ACCESSIBILITY COMPLIANCE CONSULTATION

ADA "Design and Construction" Accessibility Compliance at Parking Lot

Troon Country Club
25000 North Windy Walk Drive
Scottsdale, AZ

Troon Country Club
Exterior Parking Facility
Scottsdale, AZ

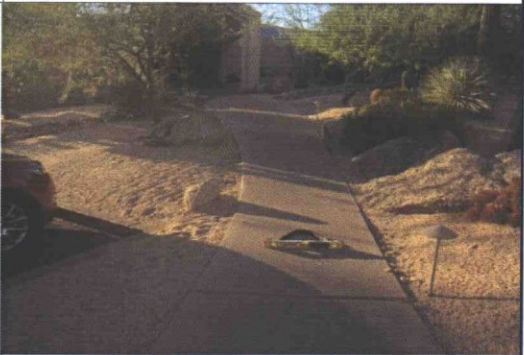
Blazik Consulting observed and measured the following non-compliant issues at the 7 existing designated accessible spaces: the accessible spaces lack a connecting accessible route to the building entry (no curb ramps or connecting walkways are provided), the accessible spaces lack a striped access aisle <u>adjacent to each space</u> (no access aisles are provided), the accessible spaces have slopes that exceed maximum 2.0% in all directions (spaces measure between 2.4% and 4.3% cross slope along full width of the parking area), there are no designated "van" accessible spaces, and the accessible spaces lack International Symbol of Accessibility signage (no signs are provided). <i>See photos below for existing non-compliant conditions.</i>

<p><u>Photo above:</u> Existing accessible spaces lack connecting curbs ramps, striped access aisles adjacent to each space, and signage. There are no designated "van" accessible spaces with minimum 8'-0" wide striped access aisles.</p>

ADA Exterior Accessible Route
 Proposed Accessible Parking and
 Accessible Routes
 For Diagram Purposes Only

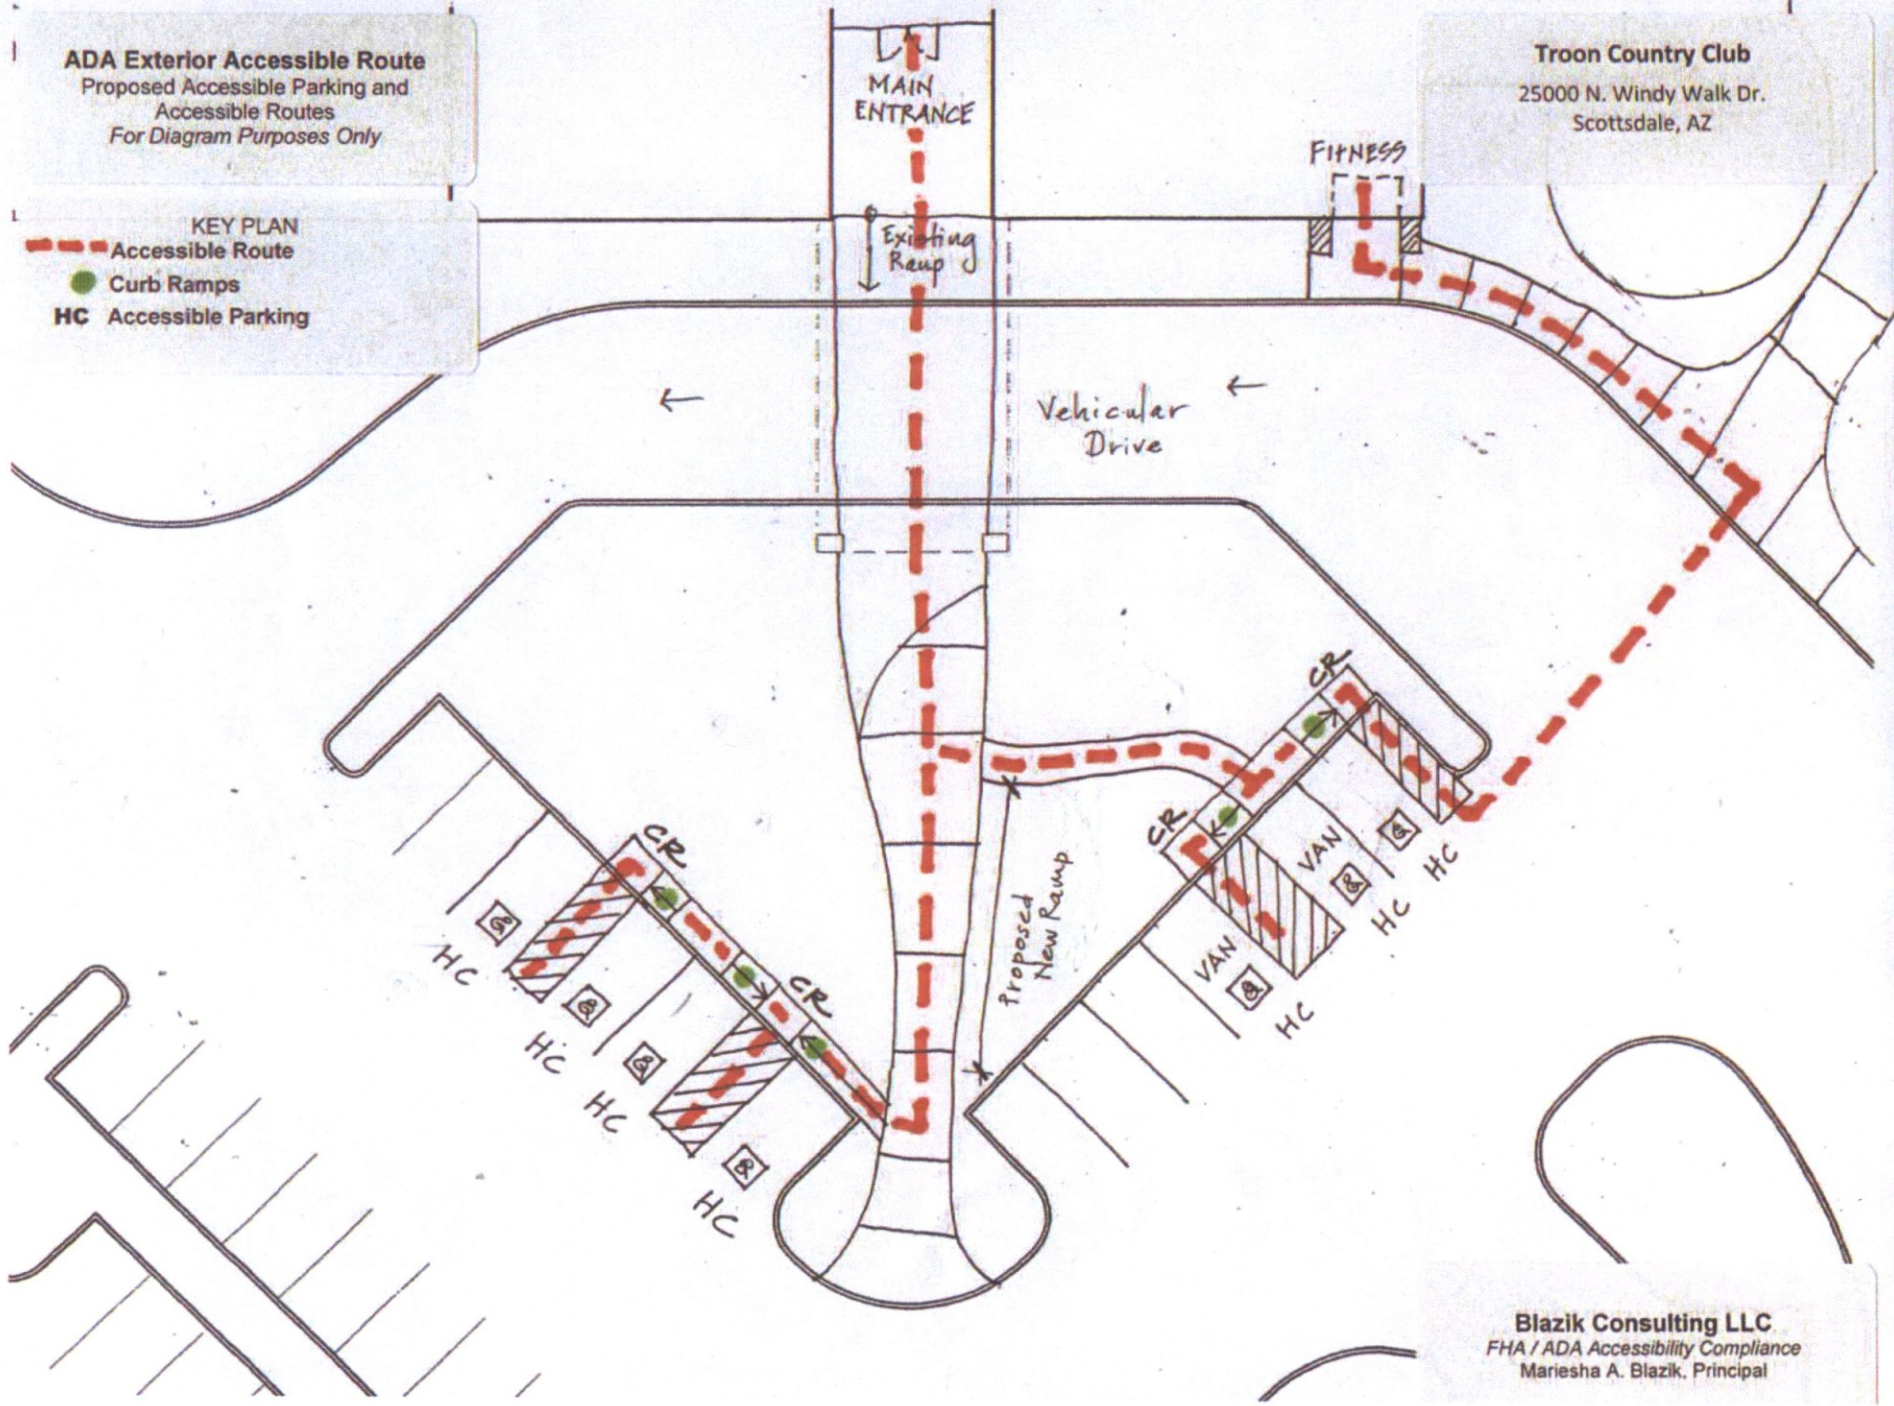
V.	Blazik Consulting LLC understands parking lot are to be repaved at all asphalt areas, including the areas subject to new proposed accessible parking locations and accessible routes. All new asphalt work to provide compliant surfaces and slopes at locations of accessible parking and accessible routes.
